# MBCA

April 29, 2019

RE: Daggett Solar Power Facility, Draft Environmental Impact Report (DEIR)

## **DAGGETT SOLAR PROJECT – Figure 2 "KOP2"** (Appendix B1, Visual Simulations Page C-4)

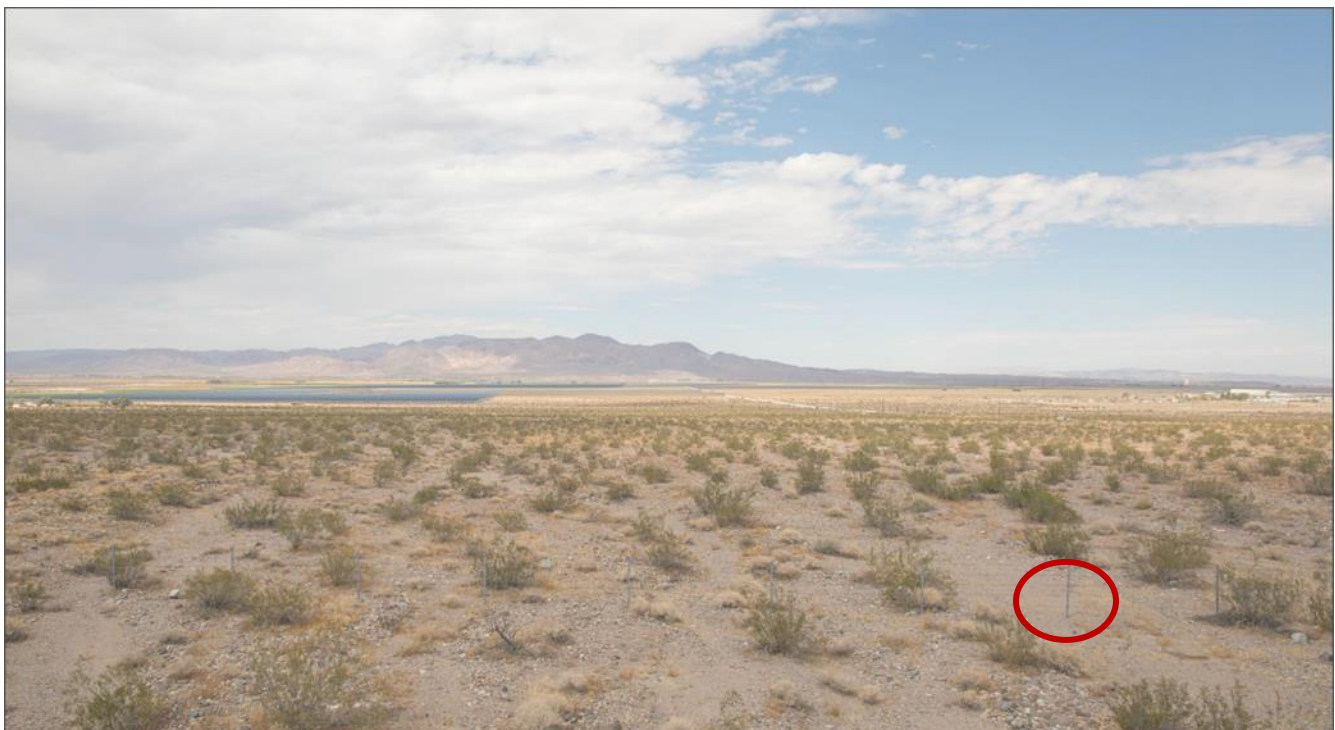
This is the DEIR photo supposedly showing the view from Interstate 40. In fact, as the DEIR admits, it's actually a view from the westbound "ONRAMP" to I-40. Based on this photo, the DEIR claims that "the project would result in a moderately low change to views from I-40". Figure 2 points put the lie to this DEIR claim.

1. This "onramp" photo is from a vantage point that is substantially lower than the actual view from I-40 itself. Look at the height of the barbed wire fence posts (circled). You can see that the photo was taken from a vantage point only a few feet higher than the 3-foot-tall fence posts.

2. The photo is taken with a wide-angle lens which makes the foreground look much larger and the background, along with the proposed solar plant, much smaller. Look at the line in the right margin. This is even with the position of Route 66 (National Trails Highway) which is visible as a white line in the distance. In fact, Route 66 is only 4/10s of a mile from the KOP2 location where this photo was taken. Yet the impression from this wide-angle photo is that Route 66 (and the simulated solar installation beyond) is a long, long distance away. In fact, the actual distance from Route 66 to the I-40 looks longer than the distance from Route 66 to the Calico Mountains beyond which are about 5 miles away.

Bottom line. The DEIR and this (and, by the way, a number of other) DEIR photo(s) give the false impression that the solar project's impact on the viewshed is almost negligible when in fact the viewshed degradation would be very considerable, at least from this Highway 40 "key observation point 2" (KOP2) vantage point.

Photo 1

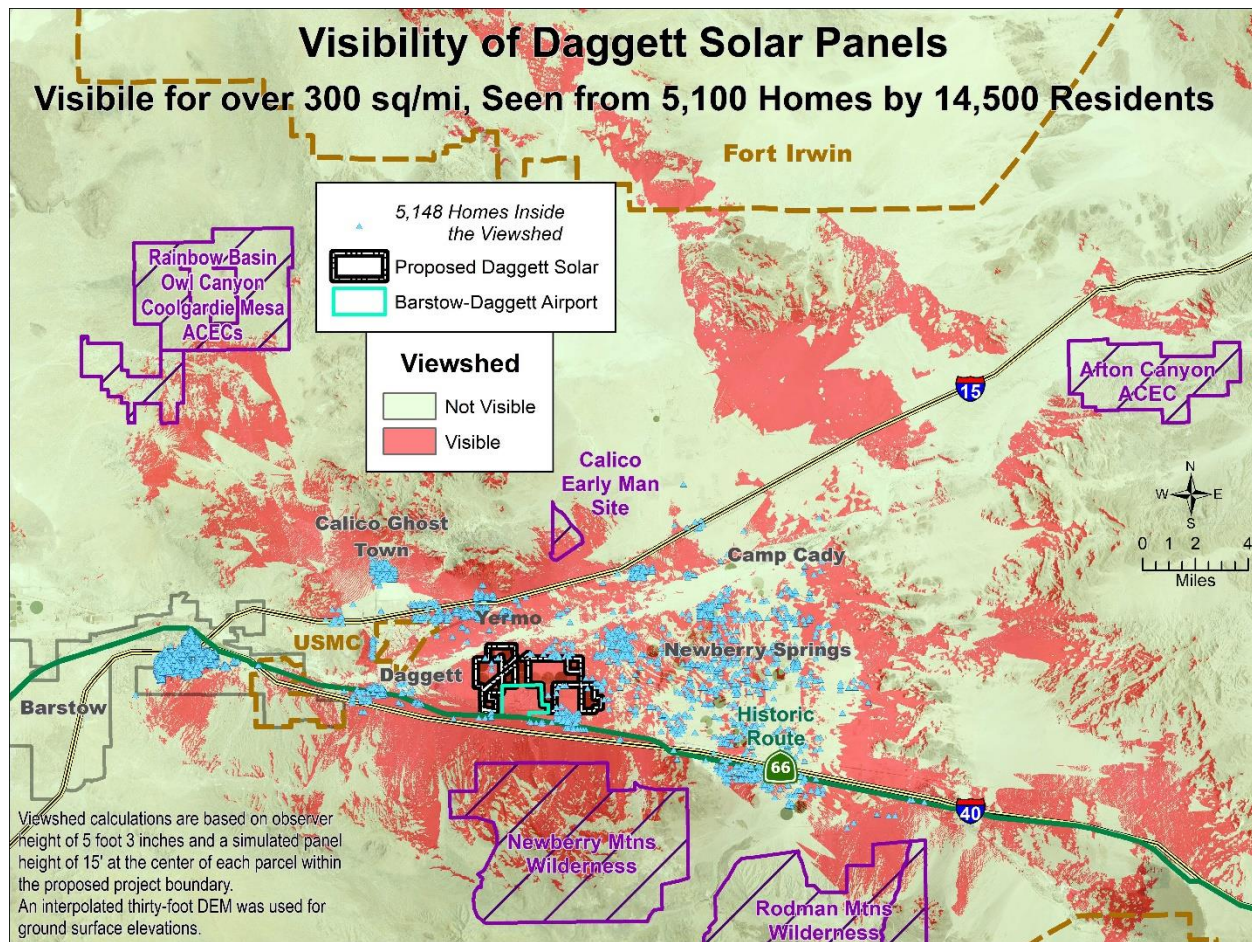
How would the VCR Worksheet analyze  
the picture to the left?

This photograph shows the 150-acres  
Cascade Solar structure near Joshua Tree  
Dry Lake in Joshua Tree. There is no  
problem distinguishing the landscape from  
the activity. The differences win out. The  
Black-throated Sparrow may find it more  
difficult. *Is that a lake where I can get a  
drink and snag a few insects?*

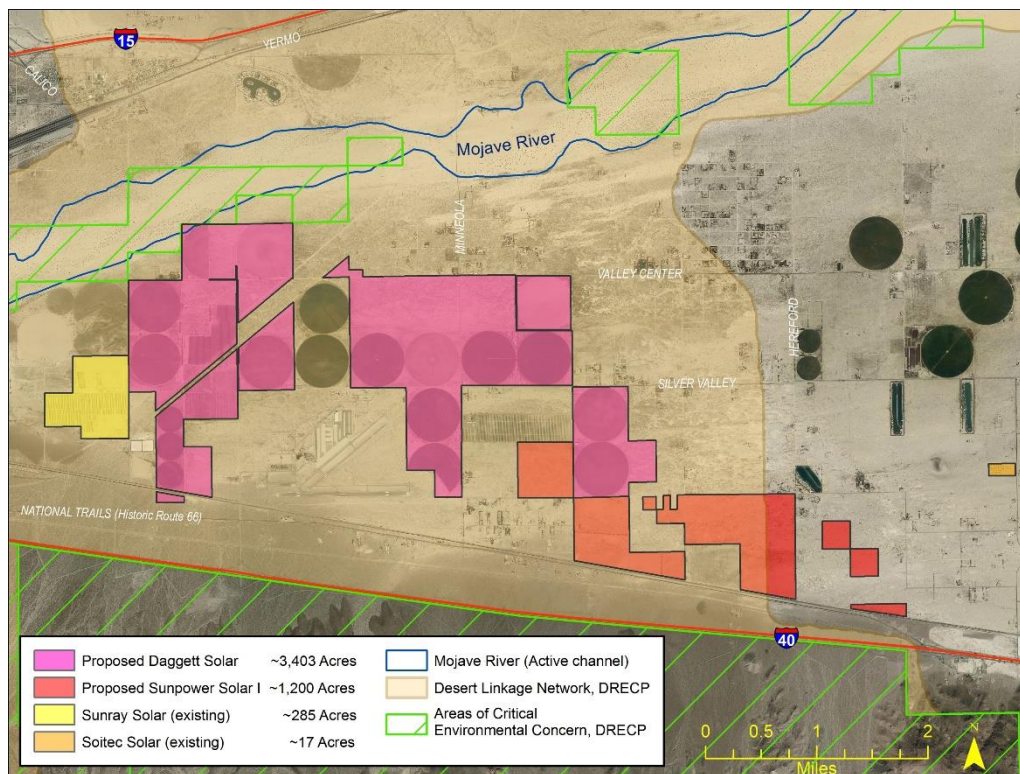
The justification provided in the DEIR for No Significant Impact is an opinion piece that is not supported by scientific data from the California Department of Fish and Wildlife or the U.S. Fish and Wildlife. The Daggett Solar Project blocks a significant portion of the passage land between the BLM ACEC to the south and link north across the Mojave River through Fort Irwin and to China Lake.

The Final EIR must analyze the linkage design as it supports both passage and live-in areas related to the Project. It is important to work with the military bases since they have a requirement not to become islands of biodiversity. This requirement is supported by the linkage design. Below are two
